DEVELOPMENT APPLICATION ASSESSMENT REPORT

Application Number:	DA2021/2364
----------------------------	-------------

Responsible Officer:	Adam Mitchell
Land to be developed (Address):	Lot 17 DP 8595, 121 Pacific Road PALM BEACH NSW 2108
Proposed Development:	Demolition works and construction of a dwelling house including a swimming pool and cabana
Zoning:	C4 Environmental Living
Development Permissible:	Yes
Existing Use Rights:	No
Consent Authority:	Northern Beaches Council
Land and Environment Court Action:	No
Owner:	Kede Peter Carboni
Applicant:	Kede Peter Carboni

C1.14 Separately Accessible Structures

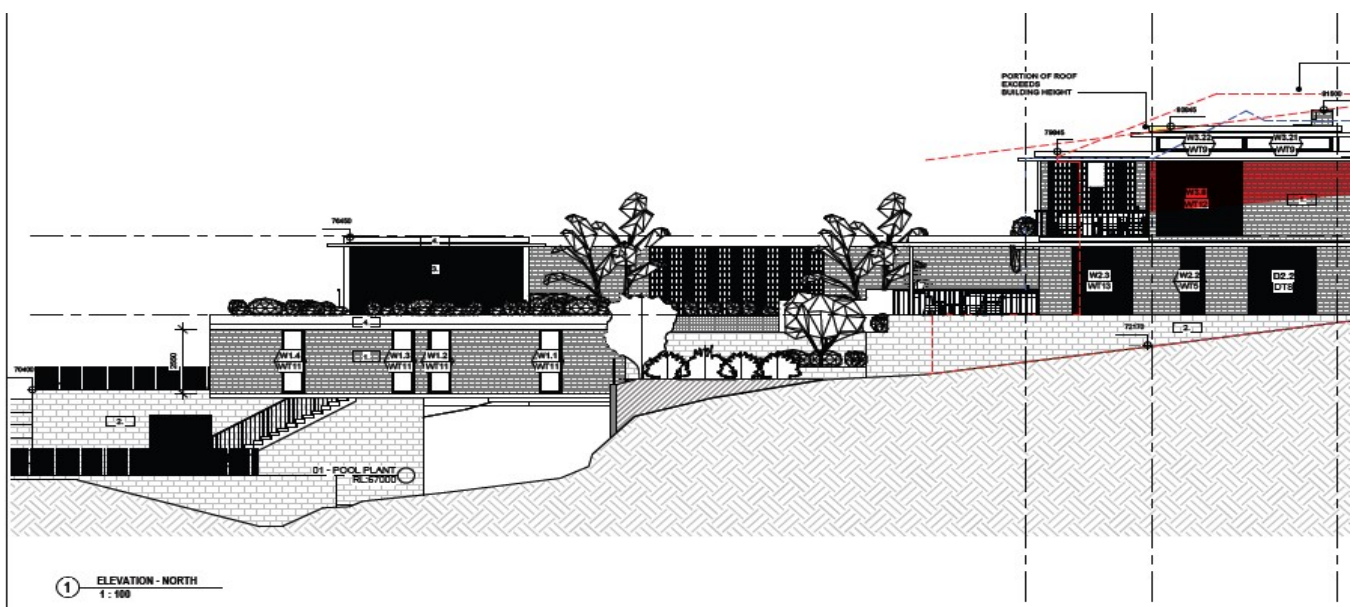
The proposal includes a small area that is detached from the primary dwelling but does not exist in isolation. That area (identified on the plans as the Basement Level) includes two bedrooms and a bathroom. The space does not contain any cooking facilities and is generally connected to the primary residence.

On this basis it is considered that the subject area is not capable of separate or independent habitation and is therefore acceptable.
